Discretionary Review Abbreviated Analysis

Date: December 11, 2014
Case No.: **2014-000335DRP**
Project Address: **2744 STEINER STREET**
Permit Application: 2014.2.14.8525
Zoning: RH-1 [Residential House, One-Family]
40-X Height and Bulk District
Block/Lot: 0563/015
Project Sponsor: Illeana Figueroa-Mills
Sutro Architects
915 Battery Street
San Francisco, CA 94111
Staff Contact: Sharon Lai – (415) 575-9087
sharon.w.lai@sfgov.org
Recommendation: **Do not take DR and approve as proposed**

The project proposes to construct horizontal expansions at three levels, including a two-story horizontal rear extension, the addition of three dormers, the replacement of the front bay projection, and regularization of the southwest corner at the third floor of the two-and-a-half story over garage single-family house. The proposal will add approximately 660 square feet of habitable space. The project also includes remodeling of the interior and other exterior modifications including new windows and doors.

EXHIBIT 1 Shadow Impacts

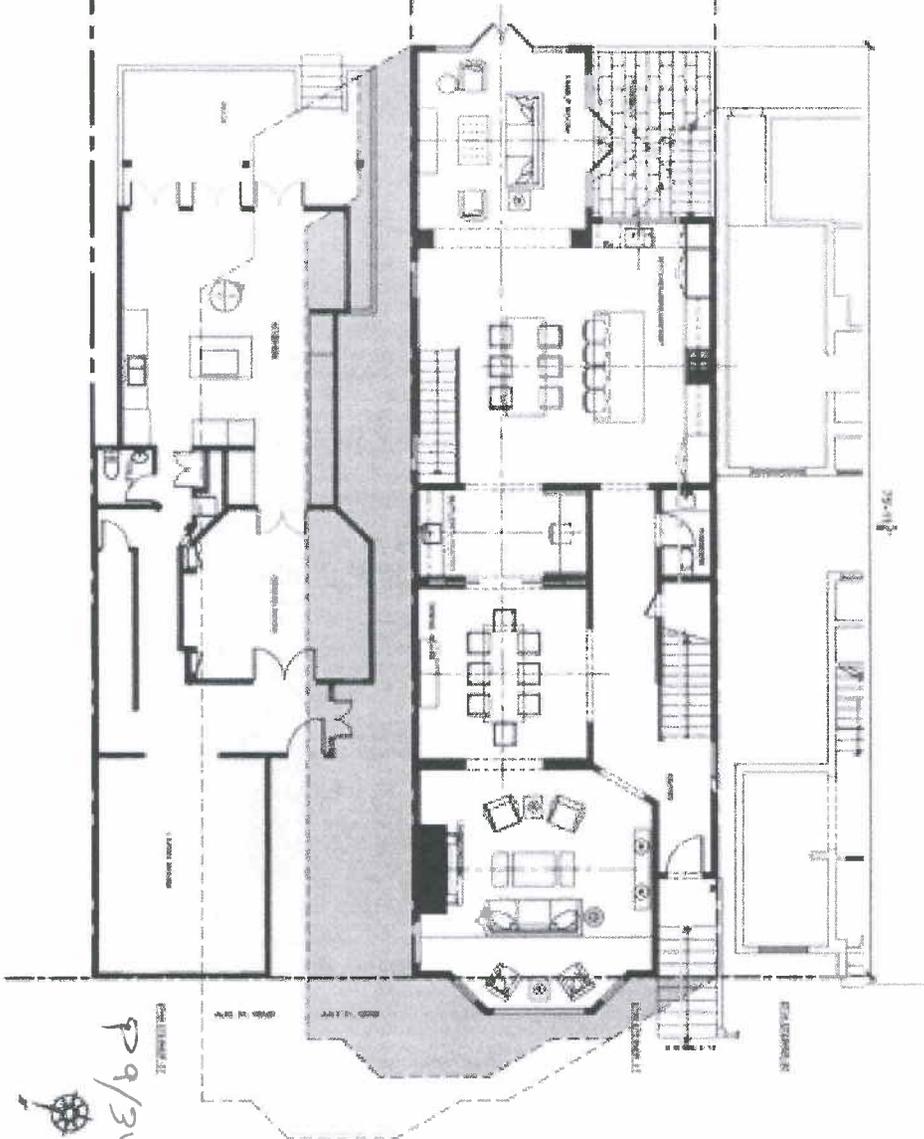
The proposed rear building walls exceed the depth of my rear first floor building wall substantially and exceeds the depth of my second floor wall to a lesser but noticeable extent. Both result in blocking mid and late morning sun to my south side windows. Looking at the existing site plan relative to my home, you can see the existing angled nature of the rear of the subject property. The subject property was constructed in 1905. My property was designed in 1912, in a way to that benefits both properties: the subject property receives early morning light by virtue of my side setback and my property benefits from receiving mid- to late-morning sun from their angled back wall. The proposal ignores this thoughtful and mutually beneficial design, offering up only a second floor side setback instead of side setbacks on both floors and rear building walls that go further out than mine. Additionally, a new third floor dormer is proposed that will look directly into my bathrooms. See EXHIBIT 4: Dormer.

EXHIBIT 3: Consistent Rearyard line

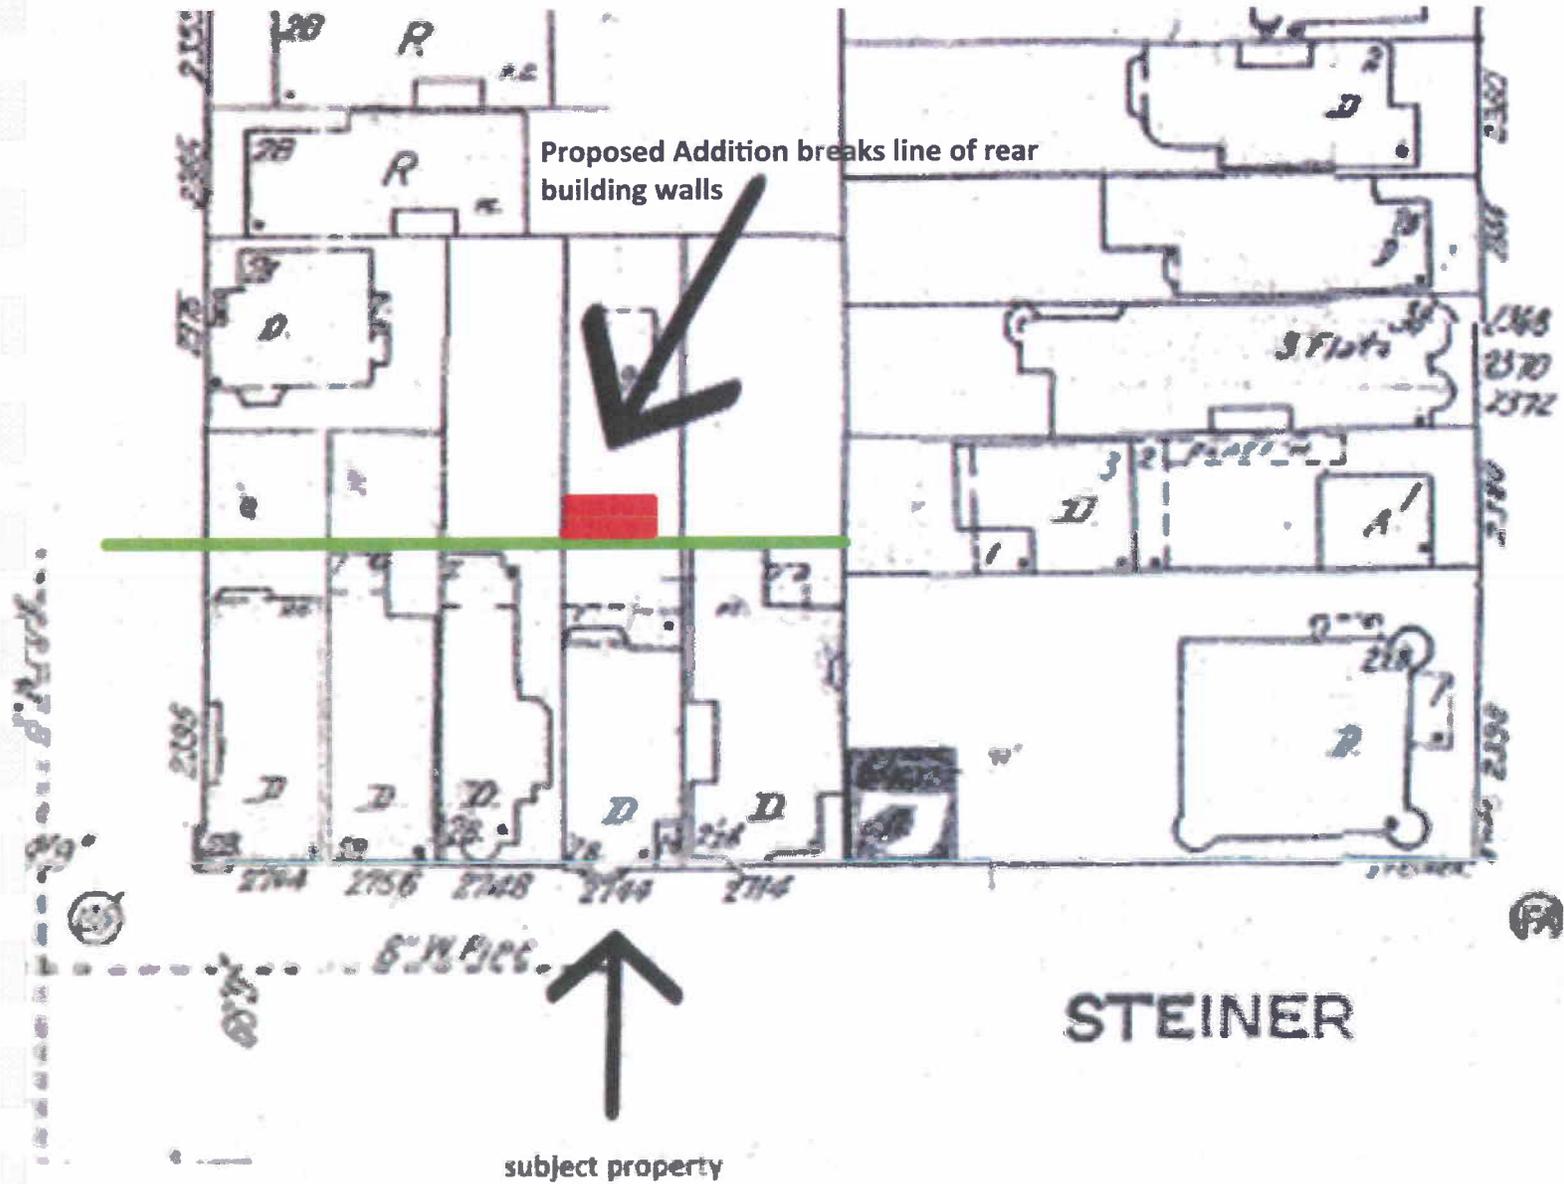
REQUESTER'S ANSWER: For over a century a consistent line formed by the rearmost walls of every building on this block of Steiner defined the west boundary of the block's mid-block open space. See EXHIBIT 3: Sanborn Map. The proposed first floor rear addition will break this line and therefore impact the contiguous nature of the mid-block open space.

Drawing Title:
VIEWS FROM KITCHEN

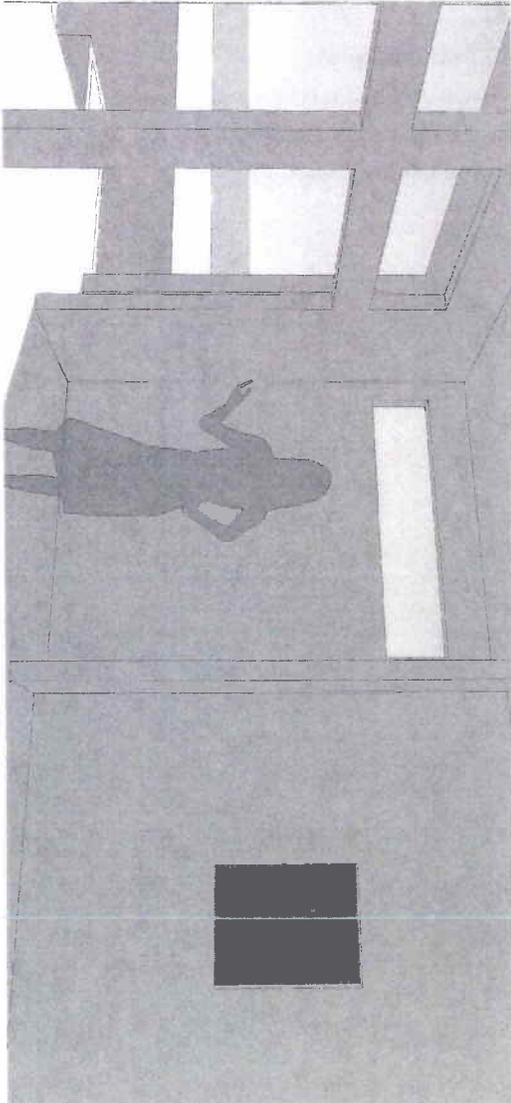
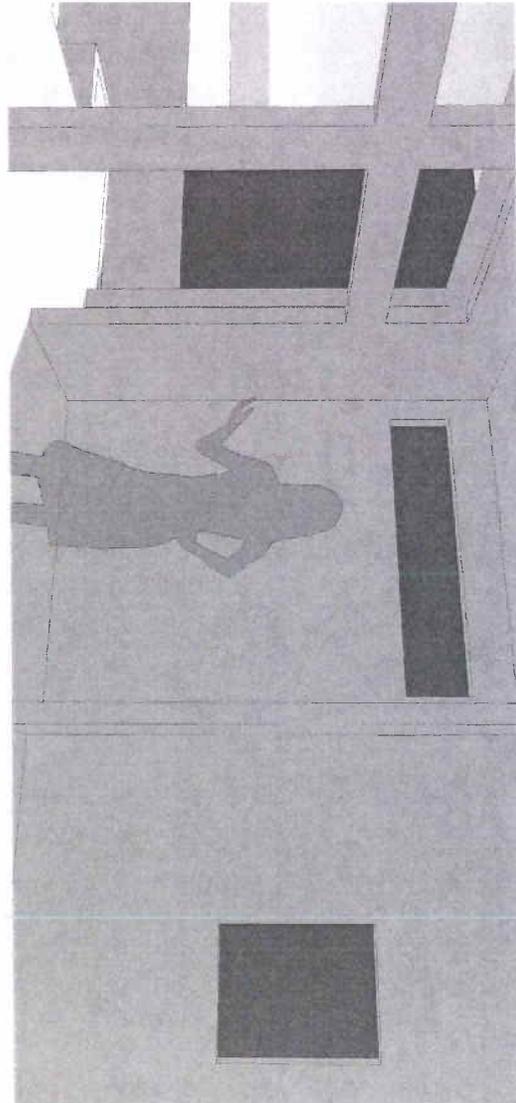
This is the picture of kitchen & family room window of 2748 Steiner Street. This window is facing 2744 Steiner Street. Southern light onto the 2748 kitchen, primarily comes through this window. Based on the proposed extension of the first floor on the down-hill side of the project sponsor, this window and the mid-morning sun will be blocked.

Drawing Title:
VIEWS FROM MASTER BEDROOM

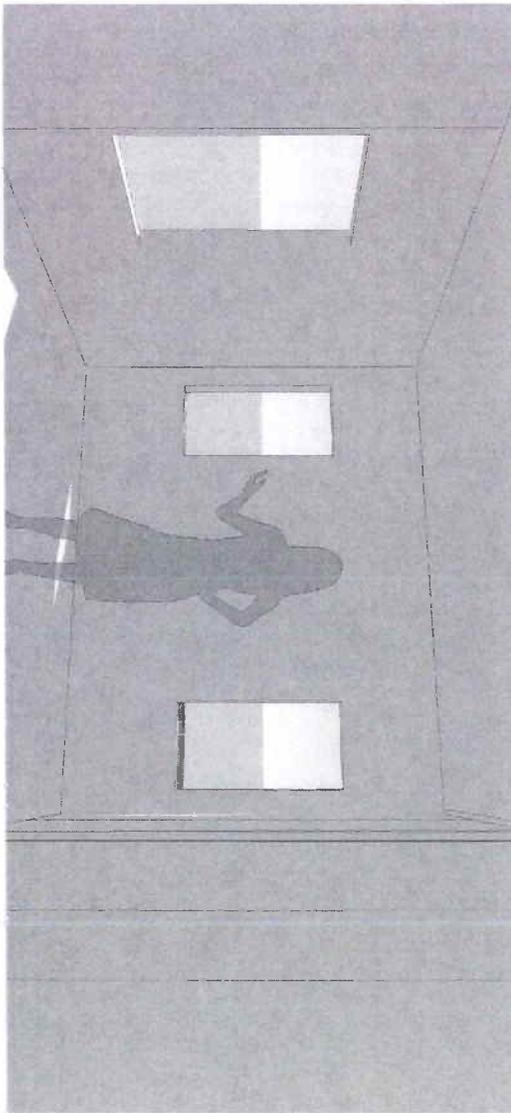
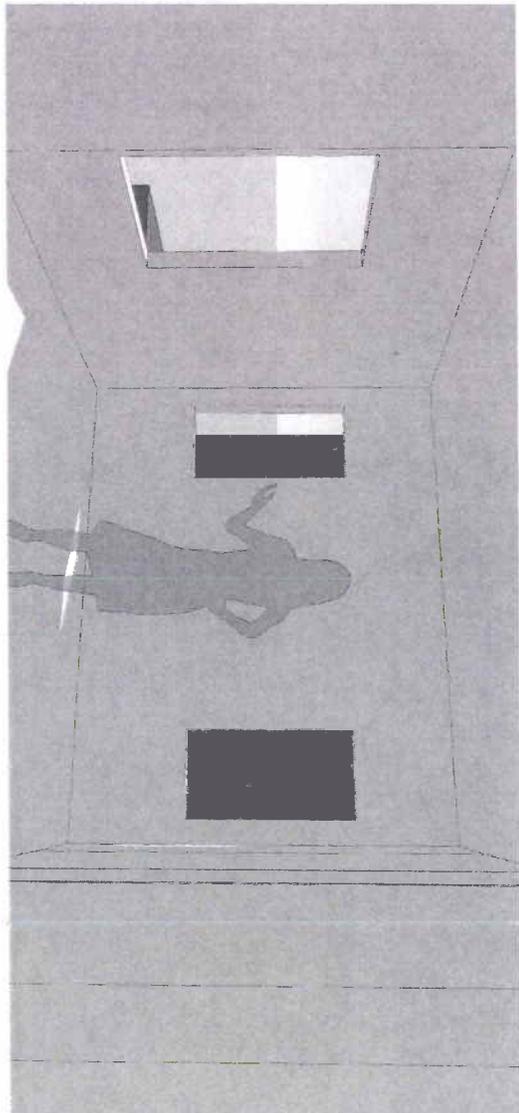
This is the picture of the master bedroom at 2748 Steiner St. The two windows depicted in this picture are facing south. The proposed second floor extension of 2744 Steiner will totally block the sun light through these windows and the room will lose the mid-morning sun light.

This picture was taken from the set back of 2748 Steiner Street. These two windows belong to the master bedroom of 2748 Steiner the northerly neighbor of 2744 Steiner (project sponsor). The proposed second floor extension of 2744 Steiner will totally block the mid-morning sun light onto the master bedroom of 2748 Steiner.

Drawing Title:
VIEWS FROM BEDROOM #1

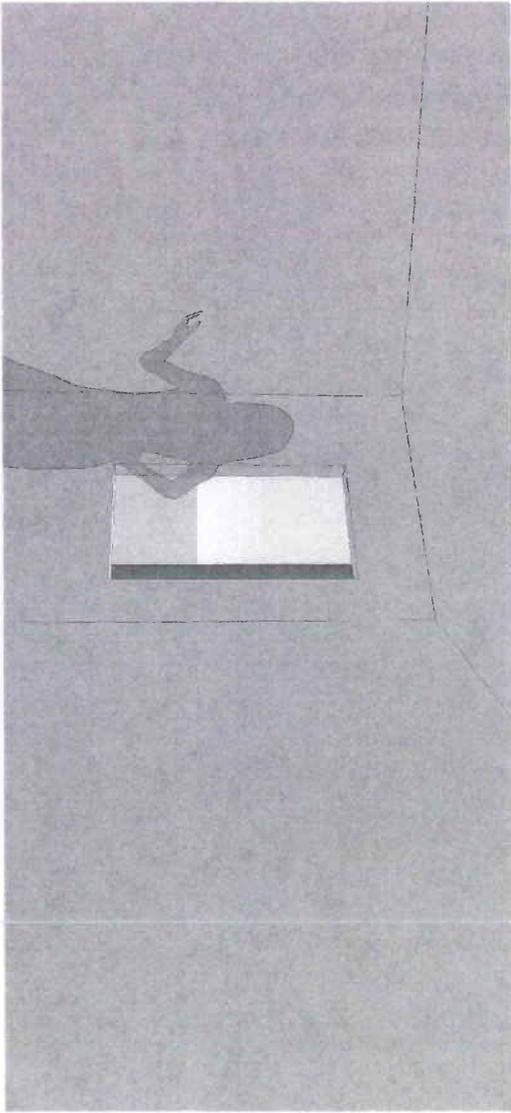
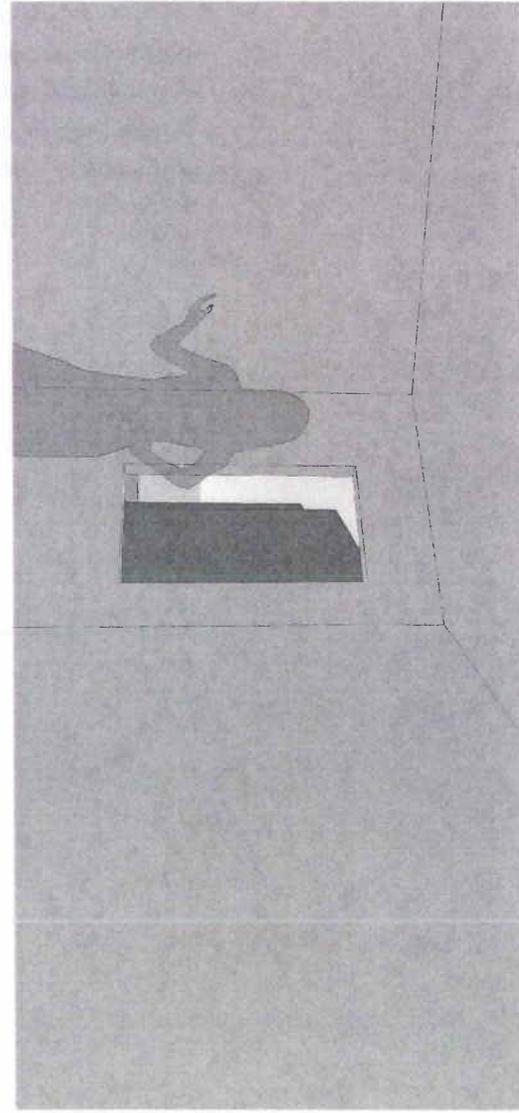
This picture was taken from the second floor bedroom of 2748 Steiner Street. The window of this bedroom is angled east & slightly toward south. Sun light emanating into this room will be blocked by the extension of the second floor of 2744 Steiner Street.

SPONSOR'S PROPOSED REVISION
(1st Floor)

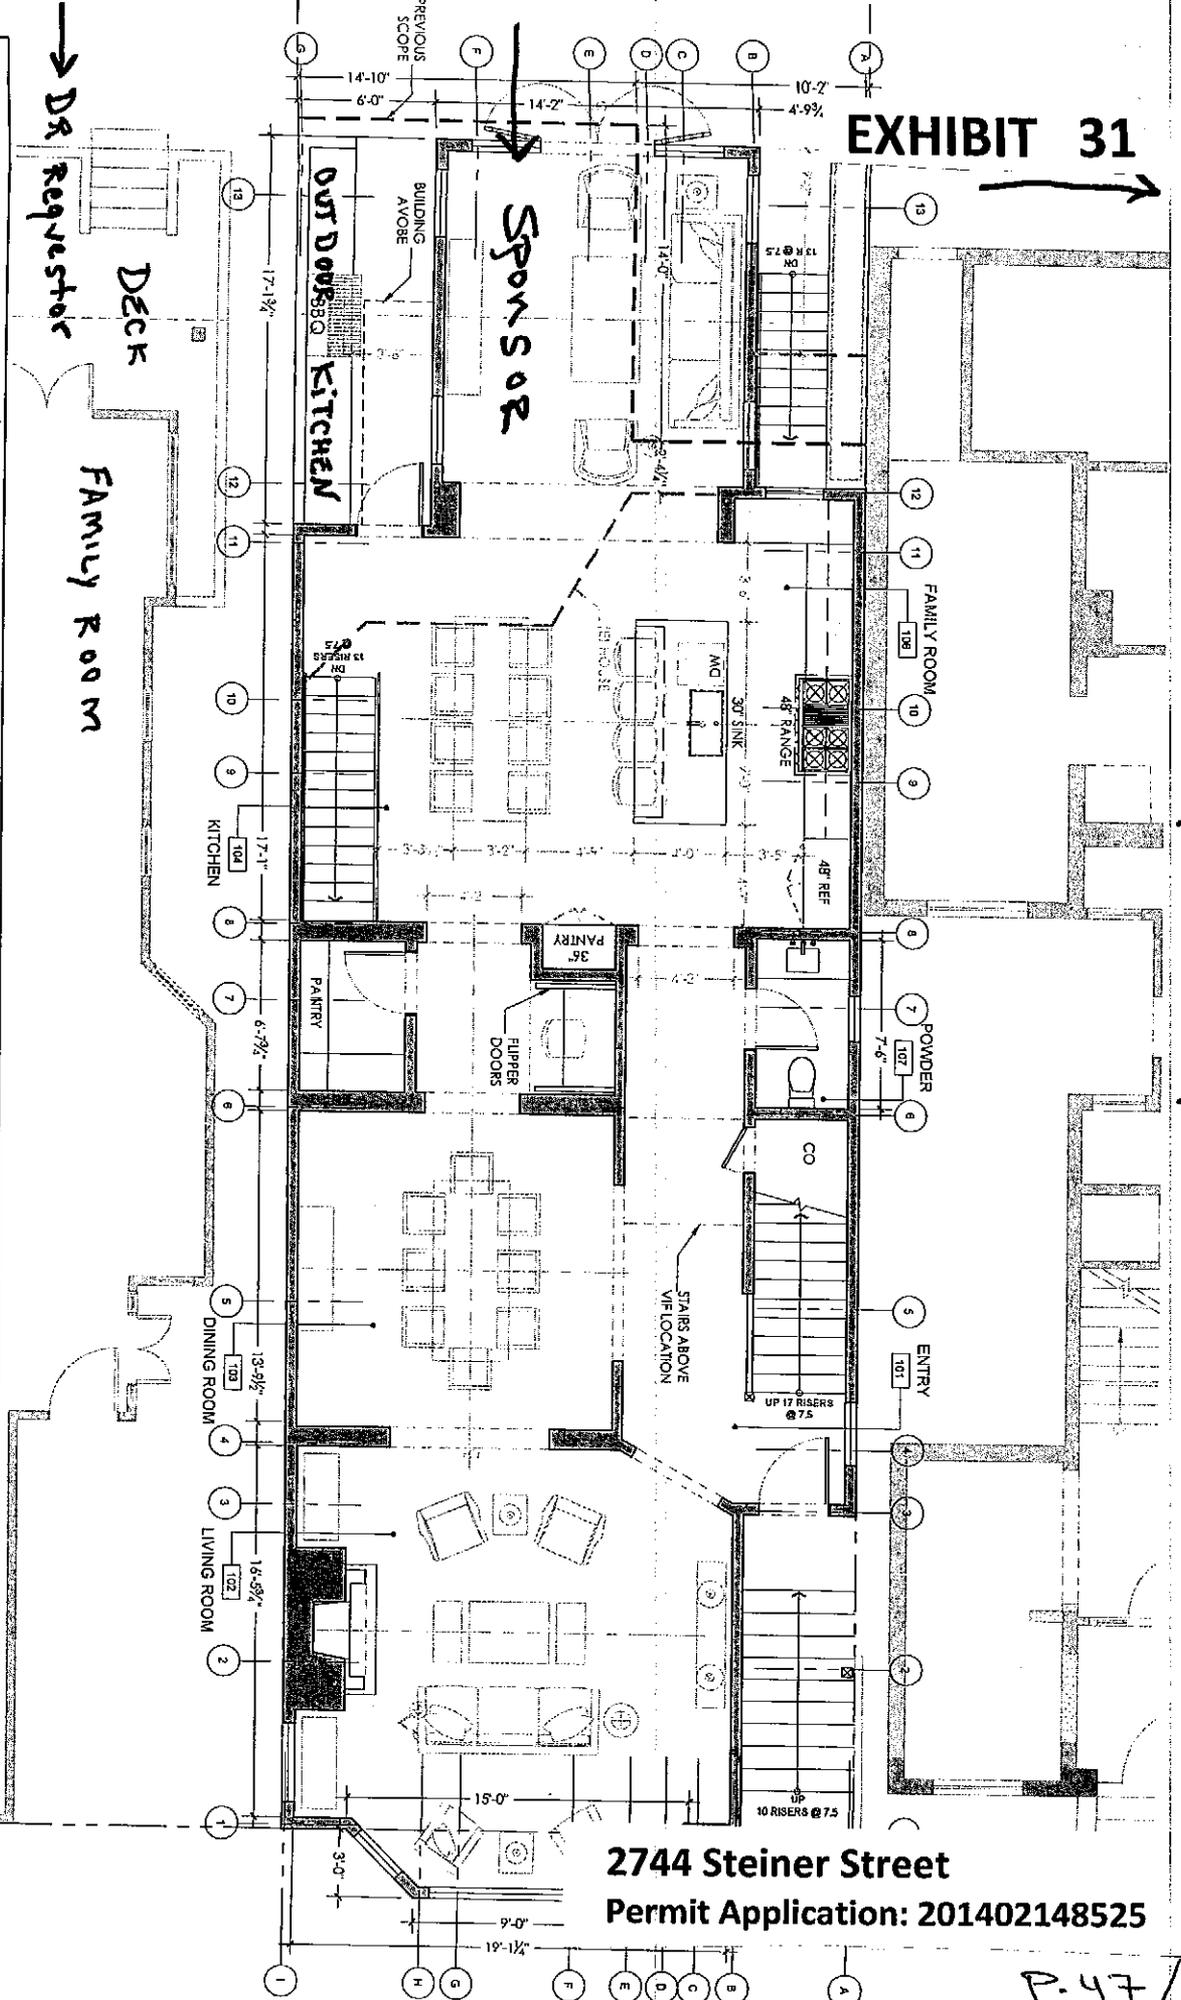
12. On June 13th, DR Requestor sent an e-mail to sponsor addressing some of the issues with the revised plan and indicating that their revised plan is far worse than the original plan. Although they are proposing a six foot set-back on the first floor, the second floor set back remains at three feet which is an overhang on the first floor. This overhang does not address the issue of LIGHT & AIR. **In addition, the sponsor proposed to build an outdoor kitchen on the six foot set-back immediately adjacent to the Talebi’s deck. Exhibit 31, Page 47 & Exhibit 32, Page 48.** In other words, by placing the outdoor kitchen next to the Talebi’s Deck and family room, the sponsor made sure that the revision is far worse than the original plan submitted to the Planning Department.
